SITING AND GRADING PLAN

From: Allan Whiting <awhiting@huntdesign.ca>
Sent: Monday, April 06, 2020 12:09 PM
To: Coughlan, Moira
Subject: [External] RE: Building Permit Application 20-496
Attachments: MASTER DETAILS.2018.11.06. - 2017 OBC - A1-MODEL-AWHITING-20200406.pdf

01 **MASONRY VENEER, 2"x6" STUDS, 2 STOREY WALL SECTION** 1/2" = 1'-0"

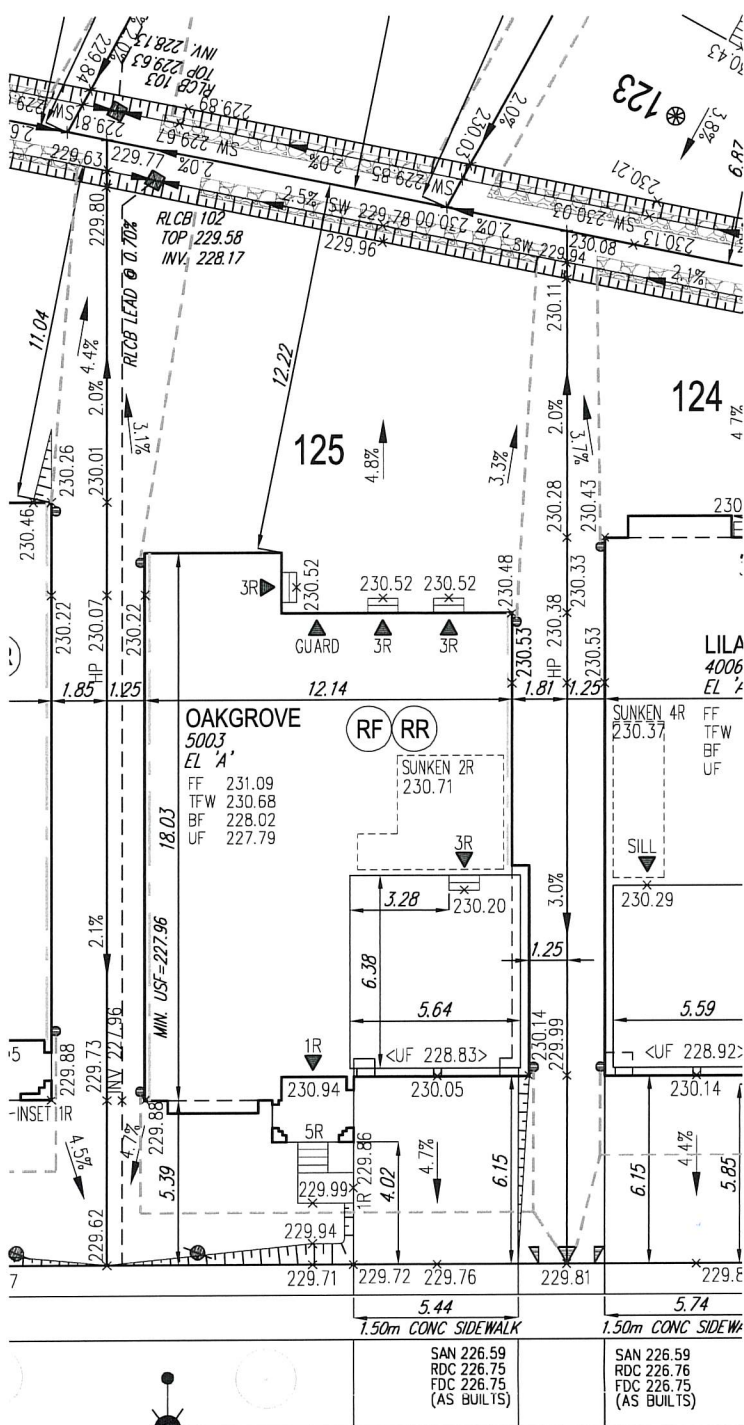
9.10.15 of the code refers to exposing building face.
Is the examiner concerned that the bumpout has a limiting distance less than 1.2m and that it should be fire rated to 45 min?

there is a code infraction with the bump out. You don't comply with OBC, Div. B,
9.10.15.

Hoping all is well. The area of concern refers to a f/p bum-pout that you are correct is not noted on the certified plans, but will be once we reapply. This was a decision that was made after these certified models were processed. I'm hoping that if there is no Code infraction which I don't believe there is, you can provide us with this approval knowing that there will be submissions made shortly on this bump out. Please let us know as this lot will impede my excavation schedule if a permit cannot be issued.

Line item 35 on the Construction Notes page of the architectural plans provides the required description. Is this suffice? Please let me know. Please see below.

35 EXPOSED BUILDING FACE w/ LIMITING DISTANCE <= 3'-11' (1.20m)
WALL ASSEMBLY CONTAINS INSULATION CONFORMING TO CAN/ULC-S702 & HAVING A MASS OF NOT LESS THAN 1.22 KG/M² OF WALL SURFACE AND 1/2" (12.7) TYPE X GYPSUM WALLBOARD INTERIOR FINISH. EXTERIOR CLADDING MUST BE NON-COMBUSTIBLE WHEN LIMITING DISTANCE IS 23 5/8" (0.60m) OR LESS. WALL ASSEMBLY REQUIRES TO HAVE A FIRE RESISTANCE RATING OF NOT LESS THAN 45 MINUTES & CONFORMING TO O.B.C. (9.10.14. OR 9.10.15.). REFER TO DETAILS FOR TYPE & SPECS. ** AN OPENING IN AN EXPOSING BUILDING FACE NOT MORE THAN 20 In² (130cm²) SHALL NOT BE CONSIDERED AN UNPROTECTED OPENING AS PER 9.10.14.6.
